GULF STATES UTILITIES COMPANY

May 22, 1985
RBG - 21090
File Code: G9.5

River Bend Station - Unit 1
Docket No. 50-458

Provided for your information are Gulf States Utilities Company (GSU) Final Safety Analysis Report (FSAR) changes that were identified during GSU's indepth review of the River Bend Station Technical Specifications. These changes are provided to ensure consistency between the Technical Specifications and the FSAR.

FIGURE 4.3-22

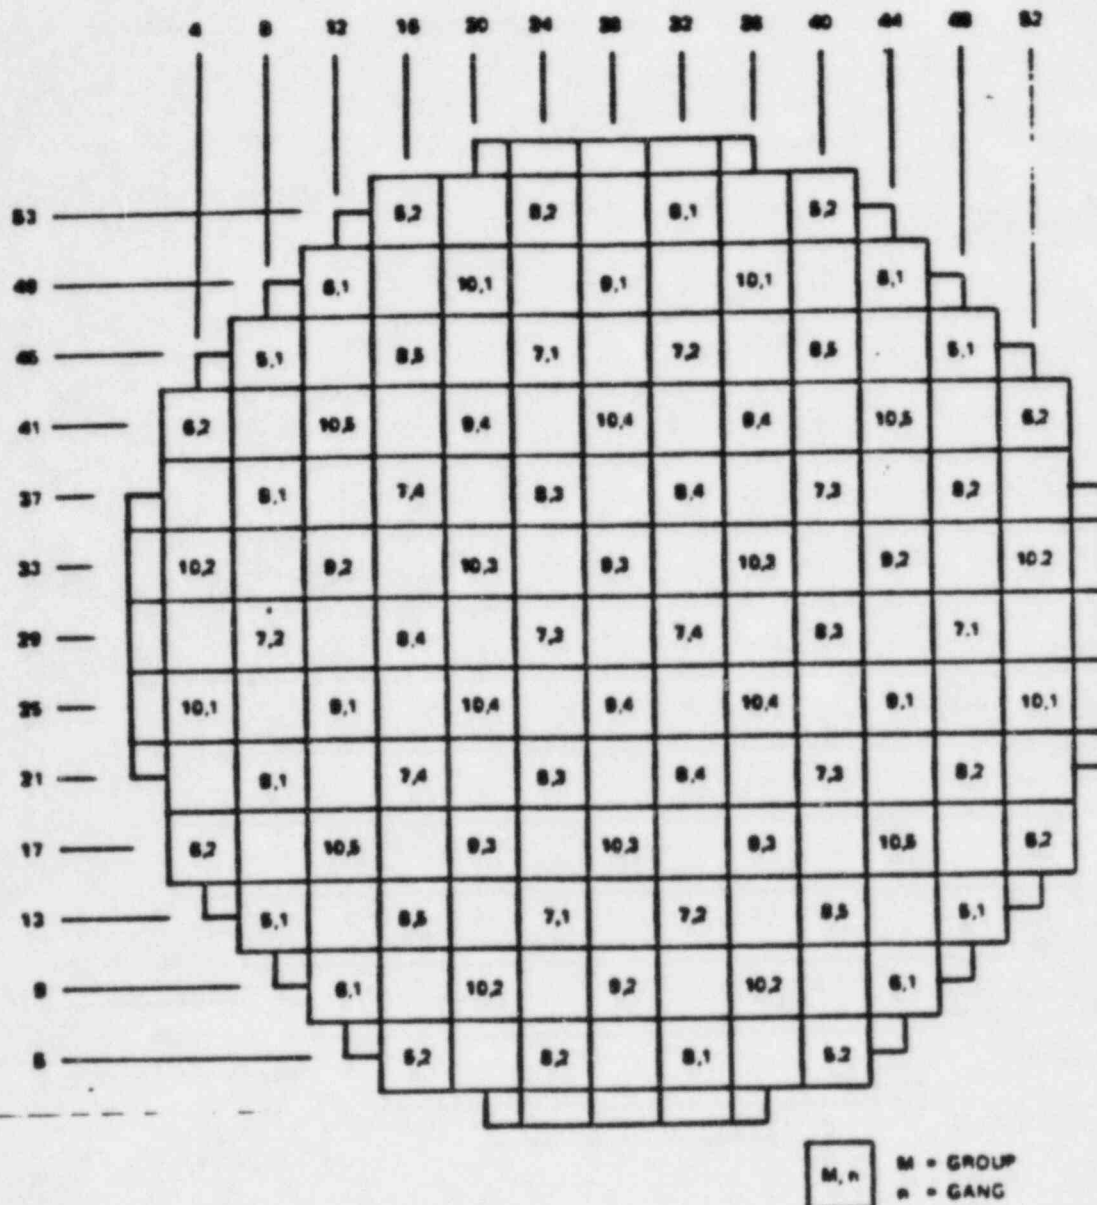
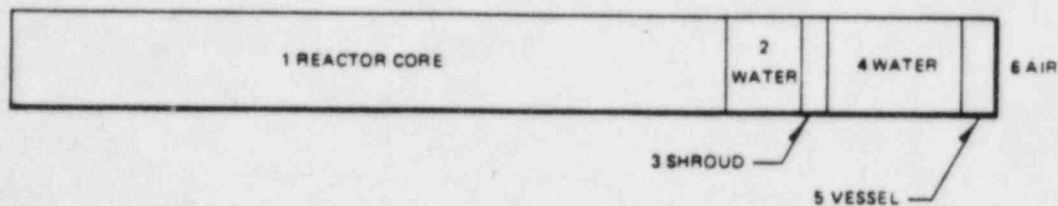
Replace with
attached

FSAR FIGURE 9.3-14
SODIUM PENTABORATE SOLUTION VOLUME/CONCENTRATION REQUIREMENTS

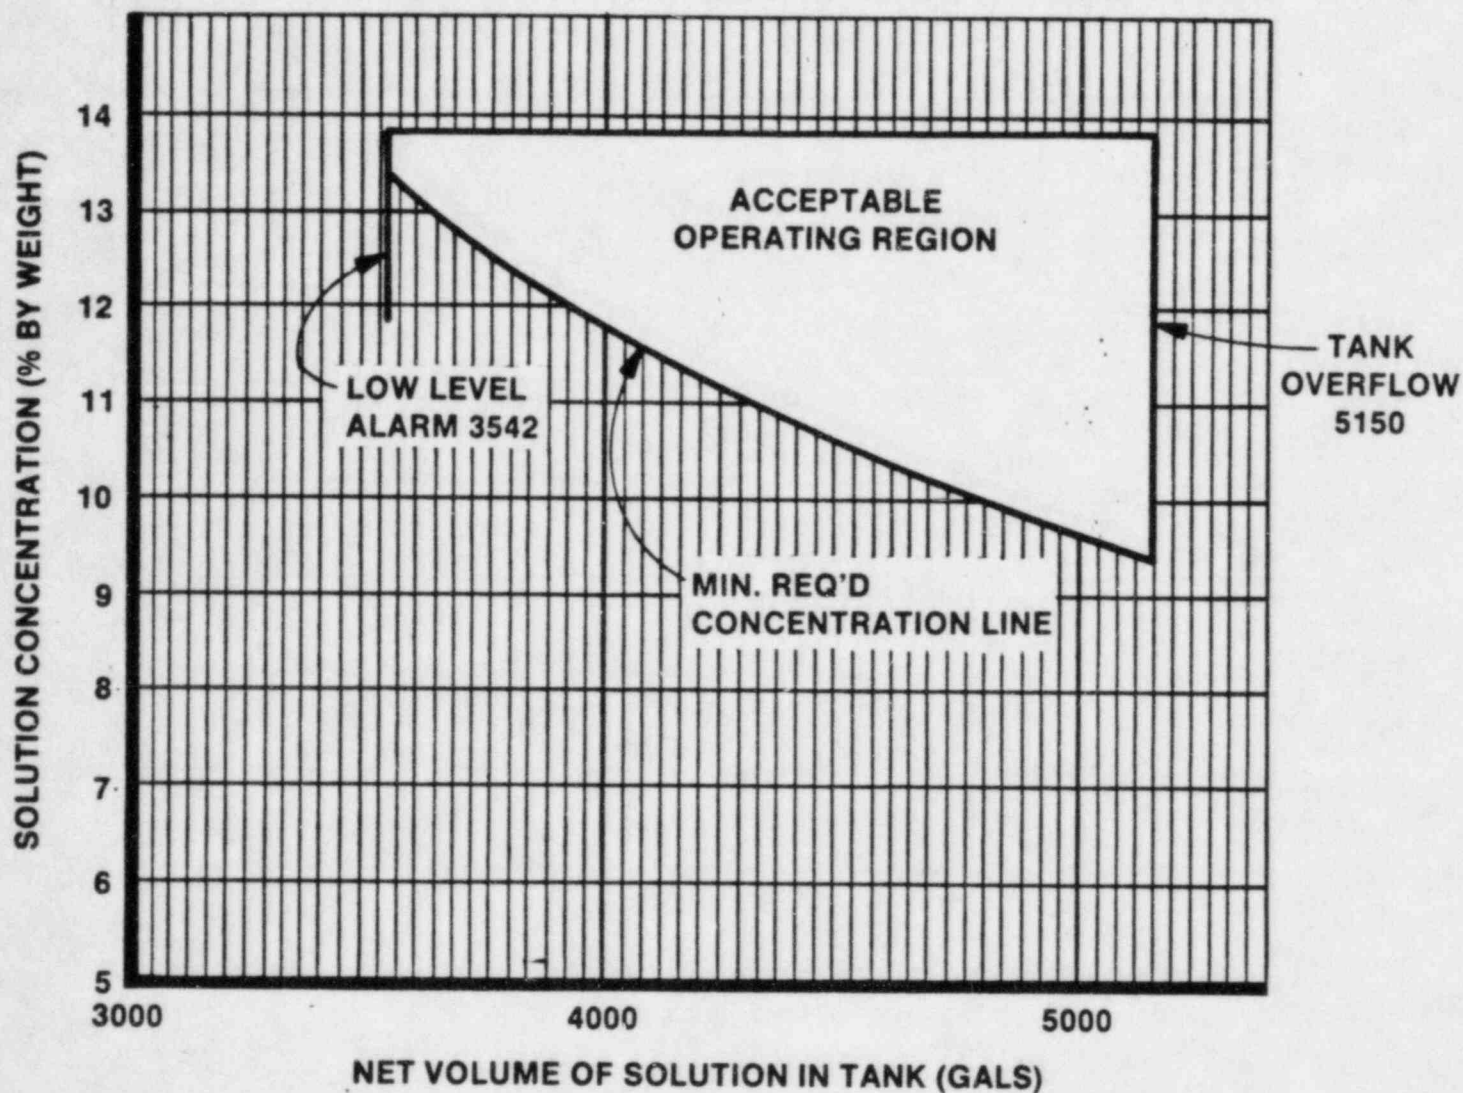
*Replace with
attached*
